Access Compliance Report Public Rights-of-Way (Curb Ramps)

Main Street: N/A Cross Street: SENDERO_WAY Location: W

ADA ID: RPRK2111222125007 Ramp Type: Type 6 - Directional 1 Initial Pass/Fail: Pass Overall Compliance: No Severity Score: 5

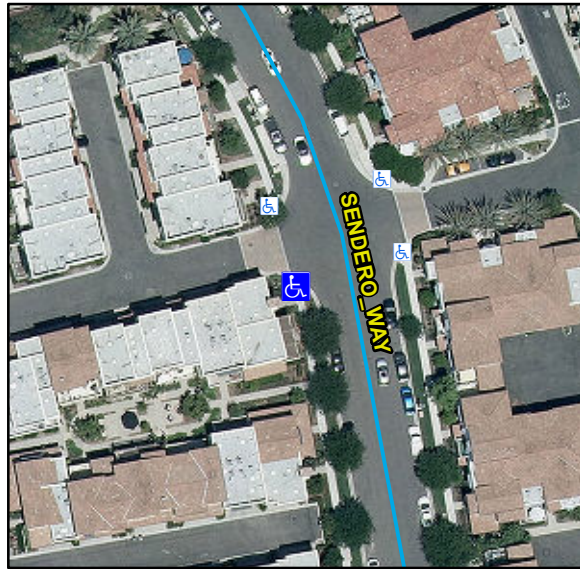
Compliance	Description	Data	Compliance	Description	Data
N/A	Ramp Length (in)	109	N/A	Flare Type LT	
Yes	Ramp Width (in)	48			Sloped
Yes	Ramp Run Slope (%)	2	N/A	Flare Slope LT (%)	8.2
Yes	Ramp Cross Slope (%)	1	N/A	Flare Traversable LT	No
Yes	Grade Break	Yes	Yes	Flare Type RT	
Yes	Grade Break Slope (%)	0.6			Curbed2
Yes	Grade Break Cross Slope (%)	2	N/A	Flare Slope RT (%)	N/A
	Addl Para Ramp Left?	No	N/A	Flare Traversable RT	N/A
	Addl Para Ramp Right?	No	Yes	DWS Provided	Yes
N/A	Landing Present	Yes	Yes	DWS Contrast	Yes
Yes	Landing Length (in)	52	Yes	DWS Length (in)	72
Yes	Landing Width (in)	48	Yes	DWS Full Width	Yes
Yes	Landing Run Slope (%)	1.3		DWS Offset Type	Single
No	Landing Cross Slope (%)	2.6	Yes	DWS Left Offset (in)	0
N/A	Landing Movement Obstructed?	No	N/A	DWS Right Offset (in)	4
	Landing Movement Type	N/A			
N/A	Landing Shared	No			
N/A	Marked Crosswalk 1	No	N/A	Clear Space	N/A
	Crossing 1 Direction	N	N/A	Clear Space To Crosswalk (in)	N/A

Marked Crosswalk 1 Width (in)	N/A			
N/A	Ramp Inside Crosswalk 1	N/A			
	Crossing 1 Slope (%)	1.8			
	Crossing 1 Cross Slope (%)	2.5			
Yes	Gutter Ponding	No	Yes	Curb Slope	1.7
Yes	Gutter Lip Height (in)	0		Road Run Slope (%)	N/A
No	Gutter Run Slope (%)	7.1		Road Cross Slope (%)	N/A
Yes	Gutter Cross Slope (%)	1		Parallel Ramp Side	Right
Yes	Overall Surface Condition	Acceptable	Yes	Perp Joint Present	Yes
	Cross Gutter Present?	No		Spandrel Present?	No
	Replace Cross Gutter?	N/A		Replace Spandrel?	N/A

Remove & Replace Landing. Remove & Replace Gutter.
